**RE: Hearing on Appeal of San Francisco Planning Commission's CEQA Exemption for
66 Mountain Spring Avenue, (Case No. 2018-007763ENV)**

Subject: 66 Mountain Spring Avenue Project [Block 2706 - Lot 025]
Wrongful Determination of CEQA Categorical Exemption
(Basis for Incompetent Discretionary Review Action)
Environmental Impact Report Required

Subject: 66 Mountain Spring Avenue Project [Block 2706 - Lot 025]
Wrongful Determination of CEQA Categorical Exemption
(Basis for Incompetent Discretionary Review Action)
Environmental Impact Report Required

A-0.3

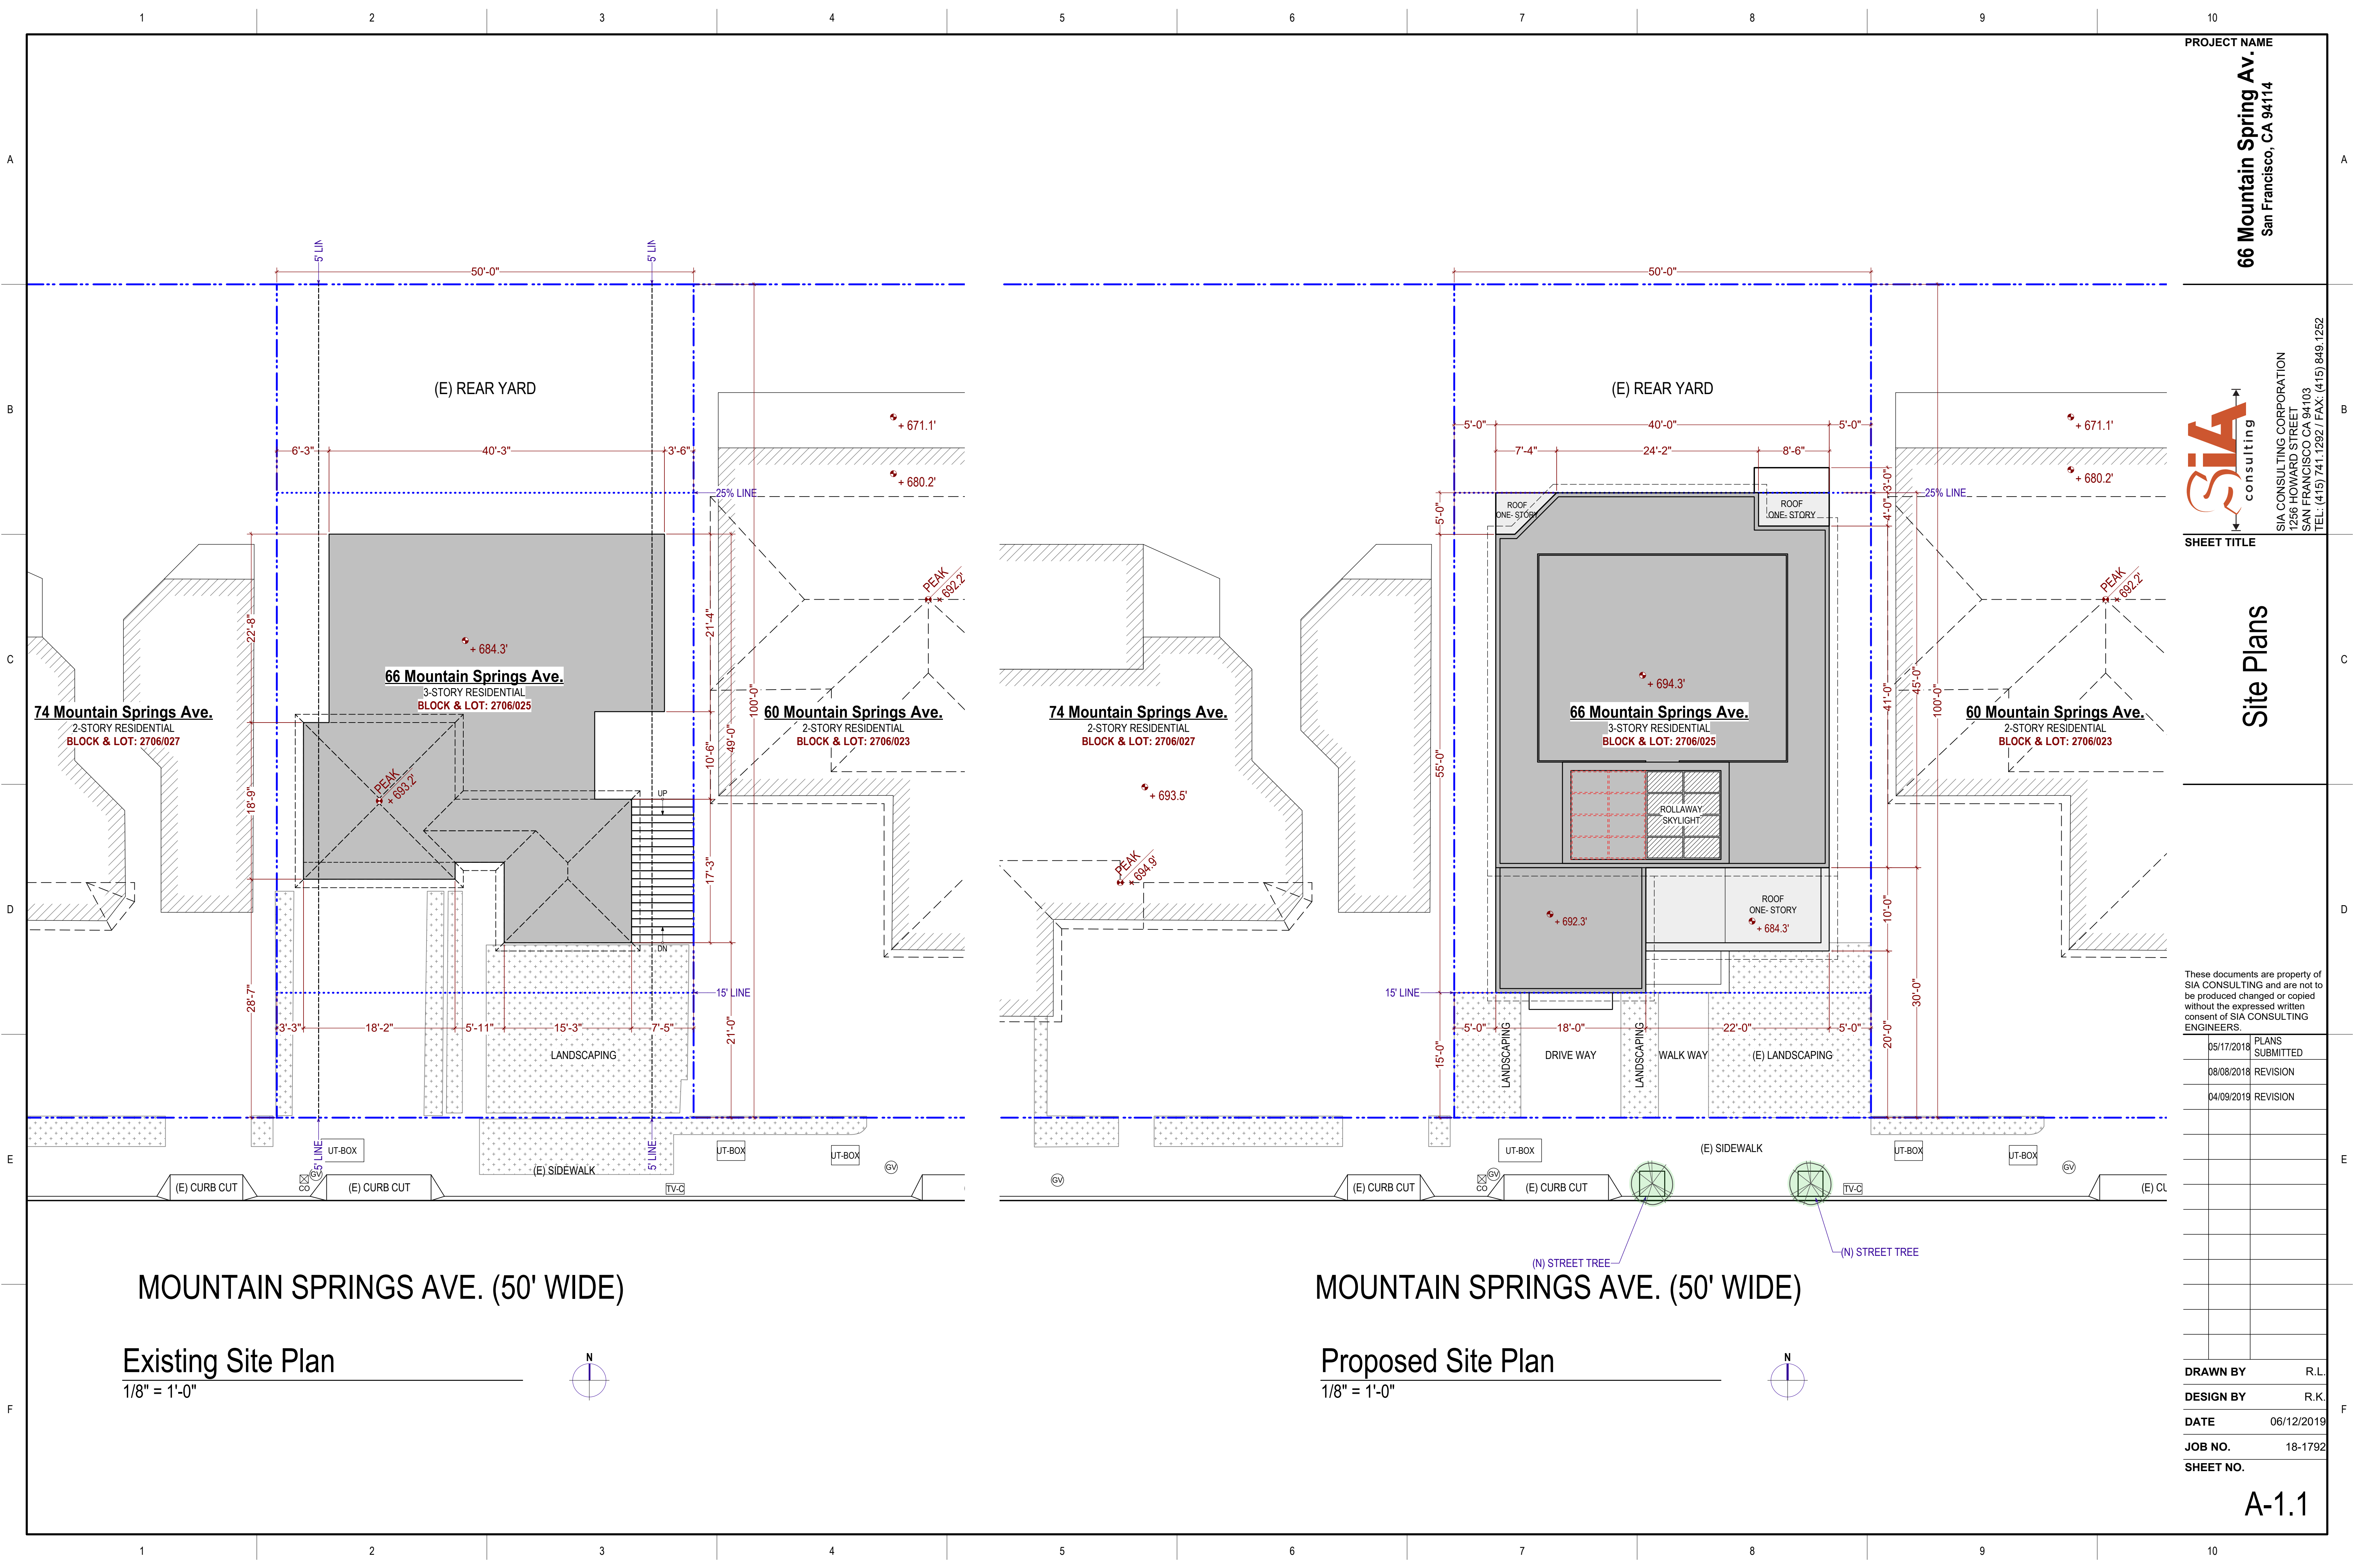
The Site Plan(s) on Sheet A1.1 totally fails to comply with document submittal regulations for permitting changes to a site where there is an existing building and demolishing an existing building (2019 SFEBBC §106.2.6) which are Slope Protection Act and CEQA issues for the necessary evaluation of site documents. No corners or lines of equal contour or elevations to City datum are shown; the SiA Consulting plans show a relatively deep excavation which reaches near the property lines to the West and East but the neighboring foundations are not located and there is no indication of the shoring necessary to protect contiguous land from loss of lateral and subjacent support which is required (2016/2019 SFBC §3307). Excavations near adjoining building foundations are prohibited (2016/2019 SFBC §§1803.5.7, 1804.1) but no provisions for shoring and underpinning neighboring structures are specified on the drawings which are both Slope Protection Act and CEQA issues because the proposed construction is in a designated landslide area.
